Ropes Creek Precinct Lot 5  
Concept and First Stage Project Application  
Transport Report

# Ropes Creek Precinct Lot 5 - Concept and First Stage Project Application Transport Report

**Re: Eastern Creek Part 3A Application  
Response to RTA and Department of Planning Correspondence**

# FUTURE DAILY COMMERCIAL VEHICLE TRAFFIC FLOWS

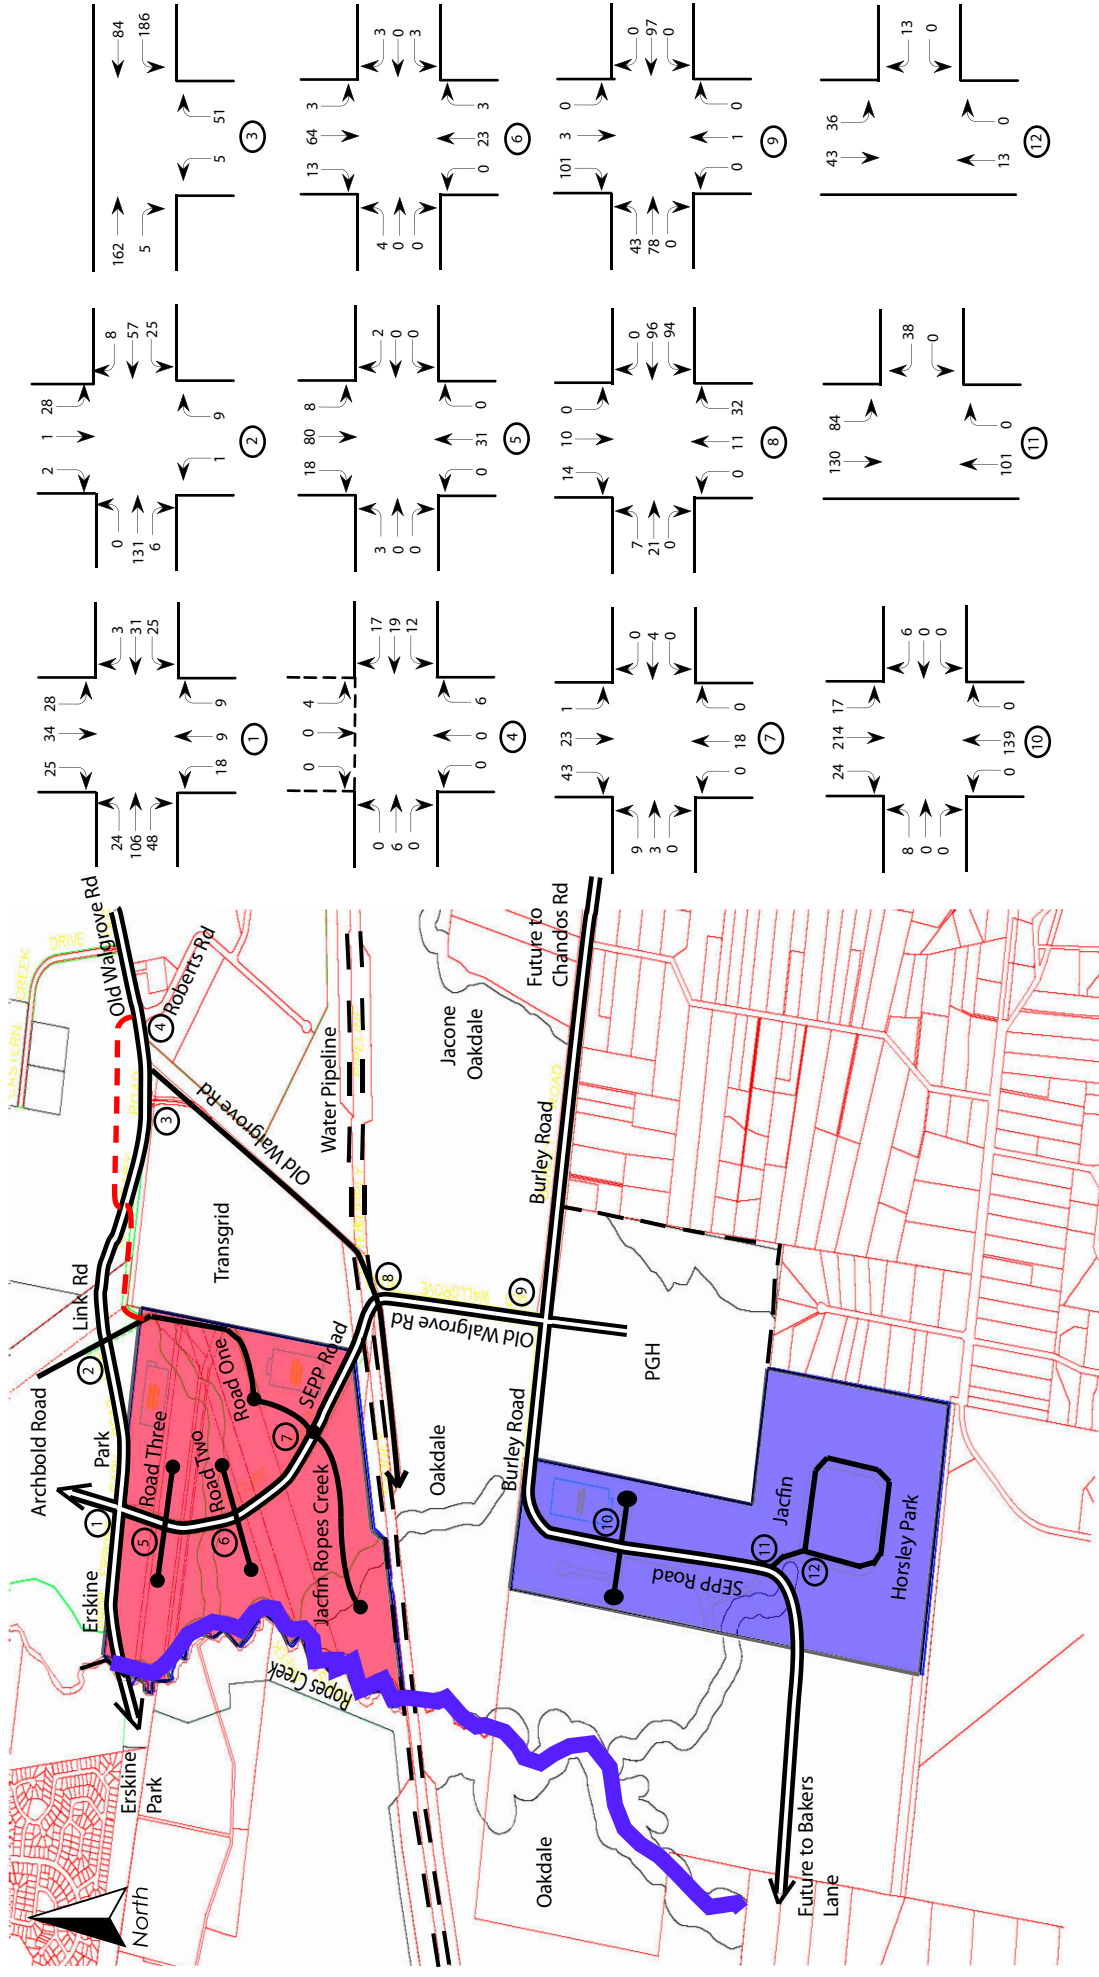
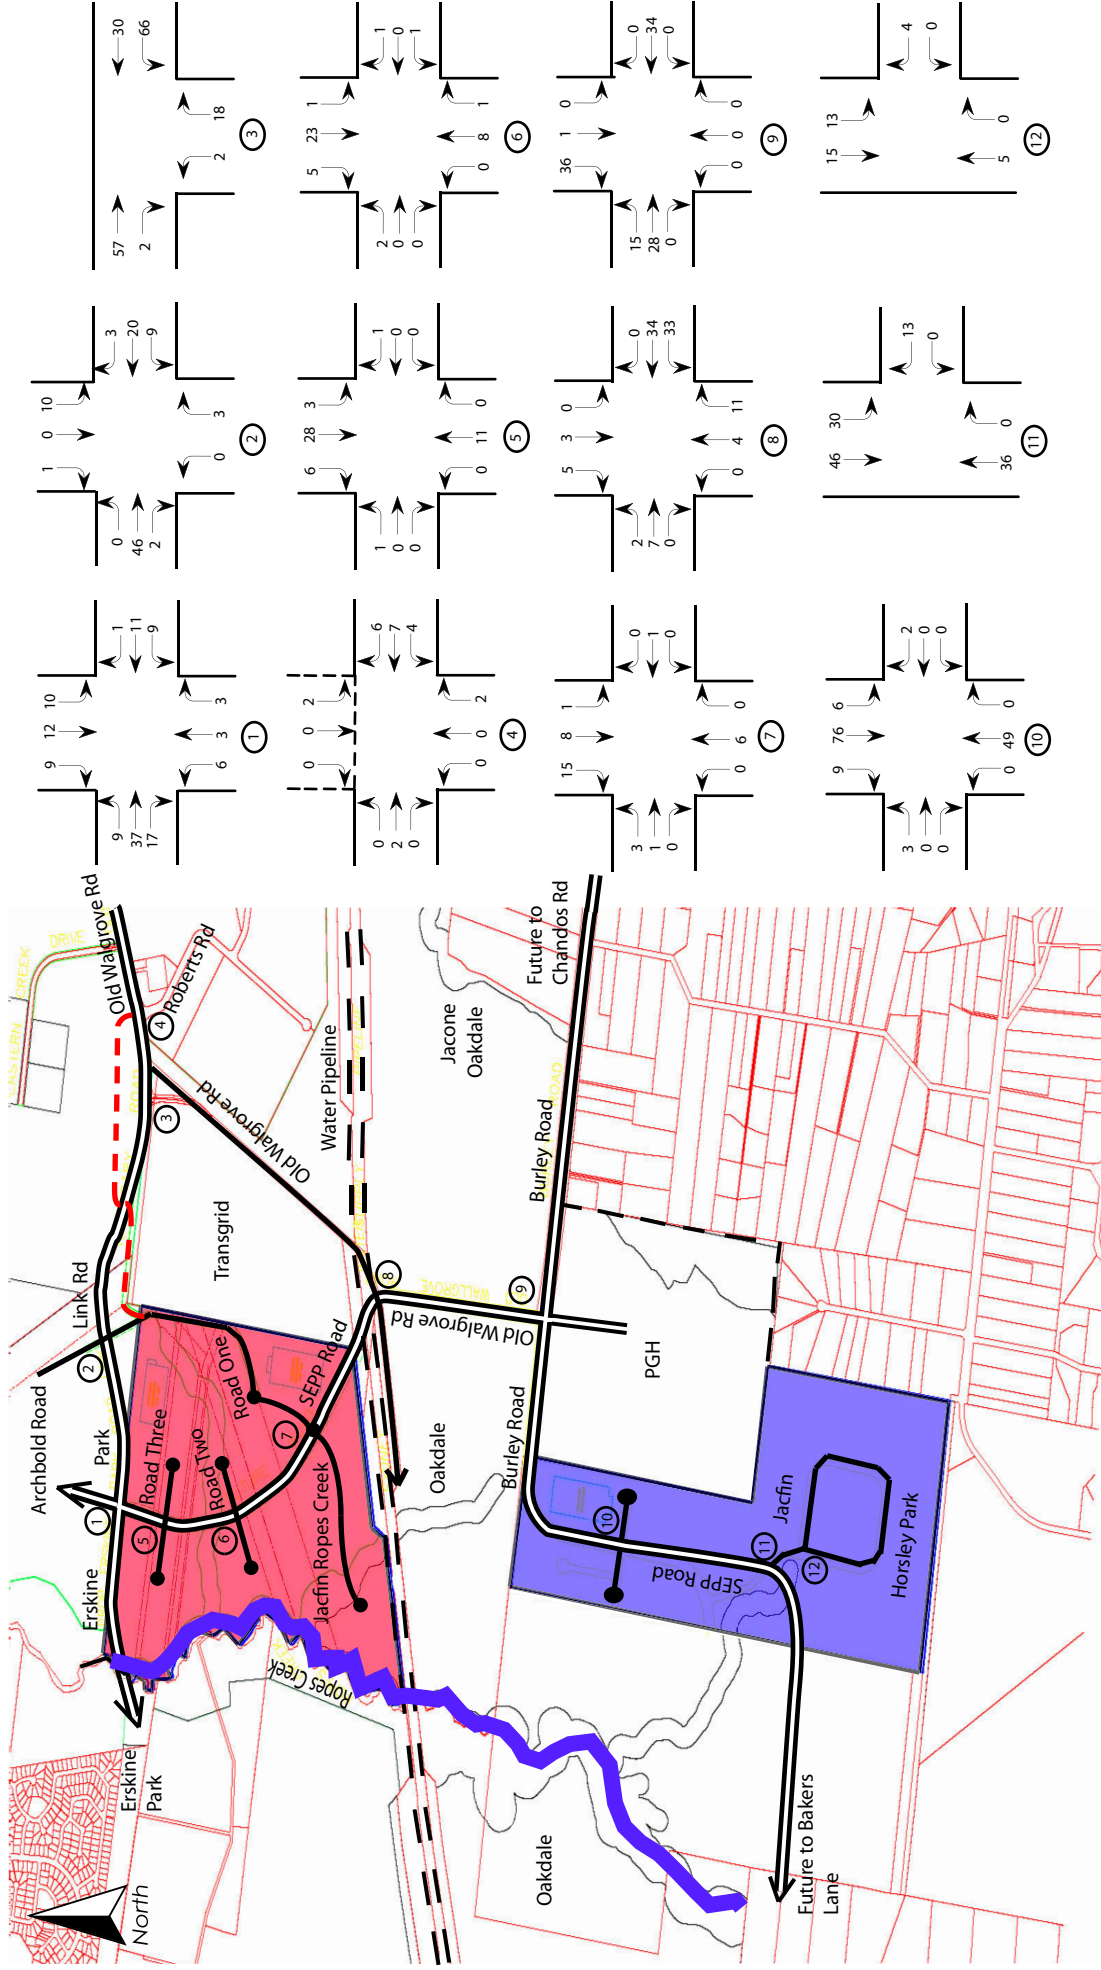
1. *“The traffic assessment does not provide adequate discussion of traffic volumes for the entire concept plan area”. “The traffic assessment should also specify the estimated number of heavy vehicles (per hour and daily)”.*

The Peak Hour Traffic Flows as shown in the Ropes Creek Precinct Lot 5 – Concept and First Stage Project Application **Figure 5** have been scaled to determine the following:

## **Appendix A - Geometric Intersection Layout (SIDRA Analysis)**

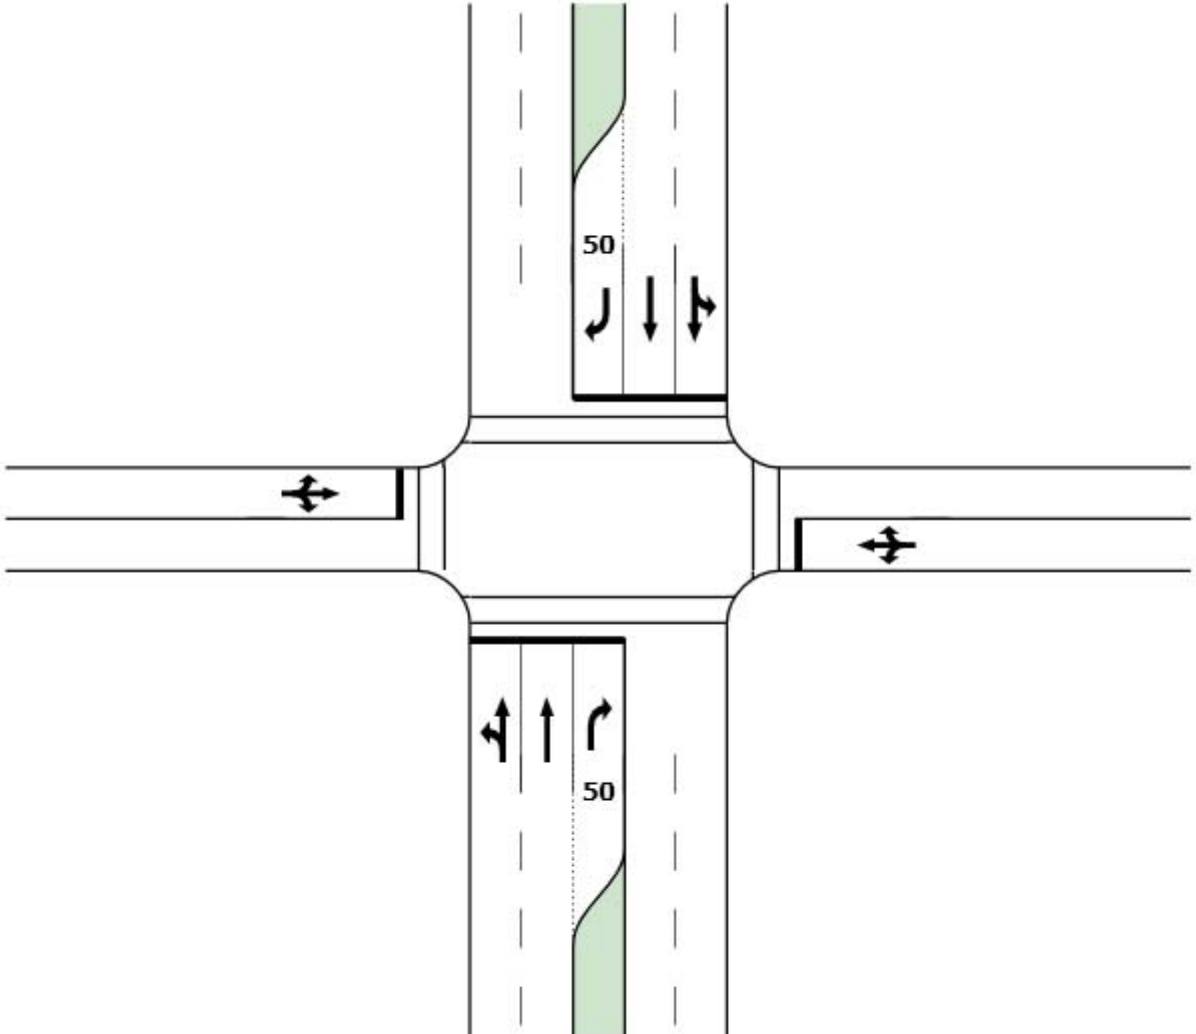
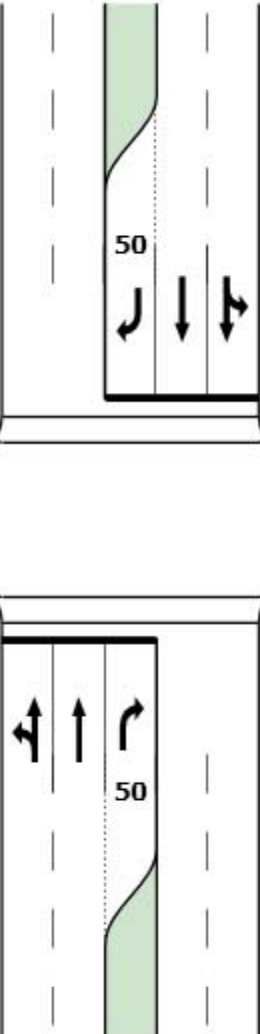
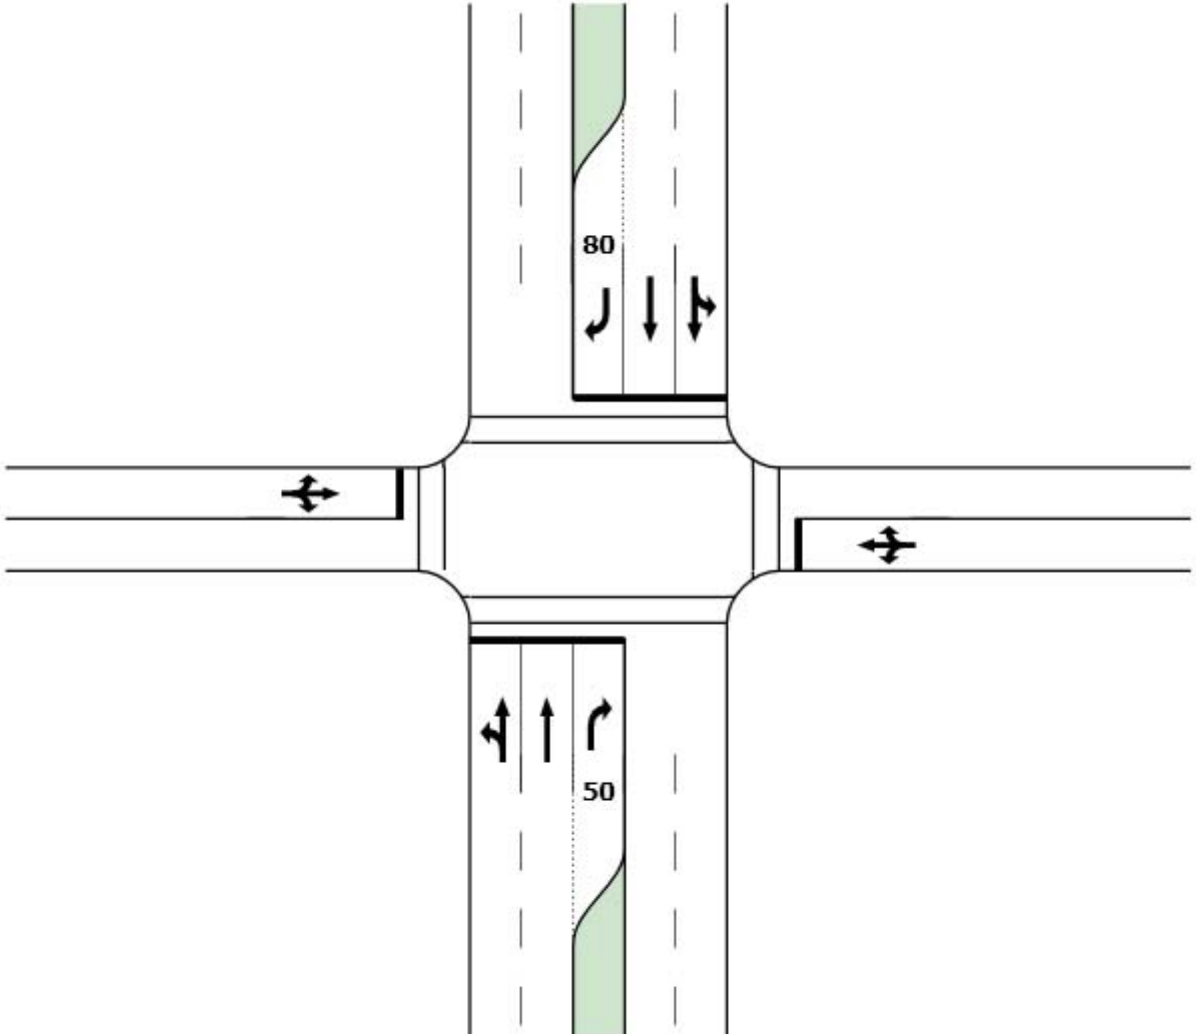
The RTA letter notes that *"the three proposed roundabout intersection located along the proposed Regional Road may not be suitable. Therefore, the draft EA report will need to examine these three key intersections in further detail by providing detailed traffic modelling outputs which examine these intersections under both roundabout and signal control."*
